ISSUES ONLY HEARING STAFF REPORT

Alder-Robinson Subdivision – Amending  
the Amended Plat of the Arcadia Heights  
Plat A Subdivision

Case #PLNSUB2010-00044

May 26, 2010

**EXHIBIT A**  
Preliminary Plat

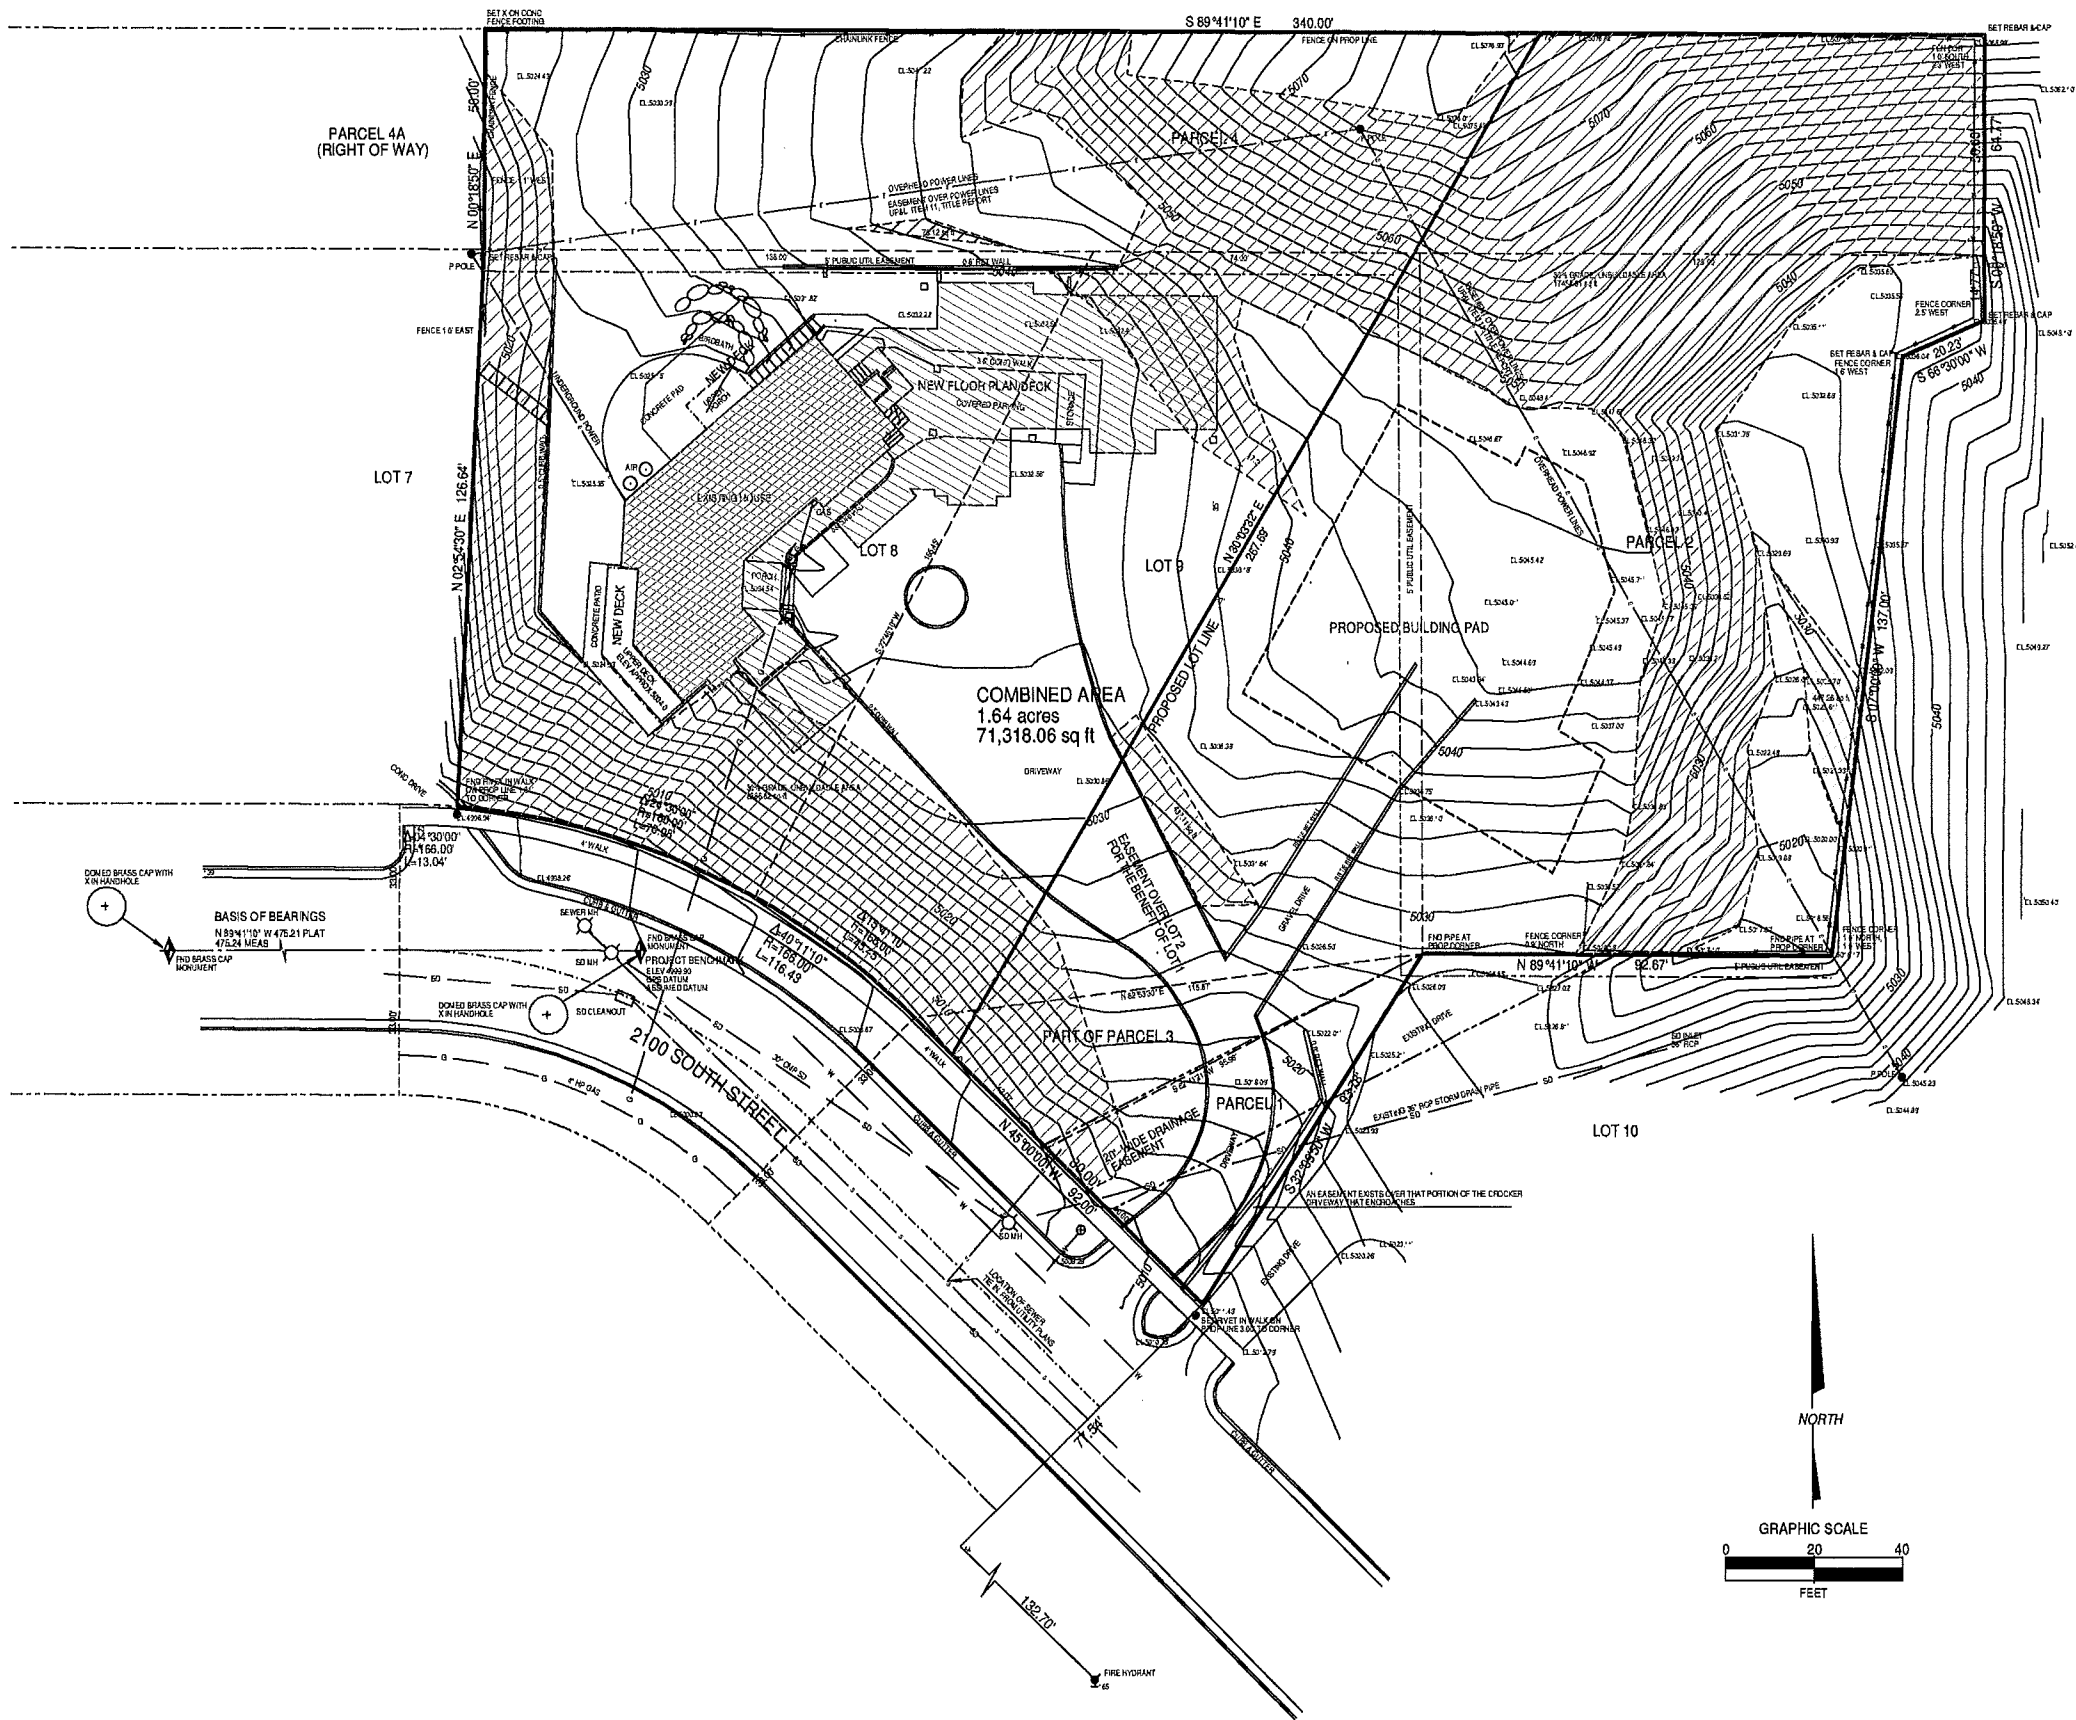
In all Foothill Residential zoning districts there are slope restrictions on lots created after 1994 that prohibit building on significant steep slopes. A significant steep slope is defined as a slope that exceeds a 30% grade. The proposed preliminary plat identifies slopes over 30%. If the preliminary plat is approved, the final plat will need to identify these areas as non-buildable.

**Analysis:** The preliminary plat shows a five foot public utility easement running through the building pad on Lot 2. According to a title report submitted by the applicant, there are no utilities currently located within this easement. The applicant will need to work with the City Department of Public Utilities and other local utility companies to either relocate or abandon the easement. This would be a condition of final plat approval.

**Analysis:** Comments from the Engineering Division indicate that the existing sidewalk, curb and gutter need repair. These issues will need to be resolved prior to the approval of the final plat.

**Analysis:** The Transportation Division has expressed concern with the driveway access to Lot 2. The concern relates to the steepness of the driveway grade (see Department/Division Comments, Attachment D). The applicant will need to provide documentation to the City that the building pad for Lot 2 can be accessed according to the City’s driveway standards as a condition of final plat approval.

**Department/Division:** Public Utilities  
**Reviewer:** Jason Brown  
**Phone:** 483-6729  
**Review Comments:** The existing meter for Lot 1 is located along the frontage of the proposed lot 2. Lot 2 must provide an easement for the water service lateral and meter for Lot 1 or the meter must be relocated along the frontage of Lot 1.

There is one panel of sidewalk with a trip hazard that must be ground down, and one section of settled curb and gutter that meets the criteria of APWA Std. Plan #291A requiring replacement. The curb and gutter must be replaced as per APWA Std. Plan 205A, and constructed by a licensed, bonded and insured contractor via a Permit to Work in the Public Way.

In reviewing the existing conditions, there are some concerns for the driveway development to comply to current design standards. Per the submitted grading plan the existing drive is at 18 – 22% slope from back of city sidewalk, with no transitions or staging area. The existing gravel drive, presumed access to the new building pad for lot 2 is at 25%+ slope. We recommend that

an access grading study be presented showing driveway access compliance to current city design standards in order to establish a building pad elevation and show the grading impact required to develop this proposed site. Driveway grades are to be an average of 16% with 6% transitions over an eleven foot run. The drive approach can be at 8% maximum grade from the flow line to the property line.

Portions of the proposed additions to the house on Lot #1 encroach into the undevelopable or nonbuildable areas, which are not allowed per 21A.24.040.G of the Zoning Ordinance. Also, all buildings must be set back a minimum of ten feet from these areas.

The plat shows a 5 foot public utilities easement bisecting the building pad on Lot #2. This will present a problem to develop the lot and it should be relocated.

The note on the driveway, "Easement over Lot 2 for the benefit of Lot 1", may need to be described more fully for recordation purposes.
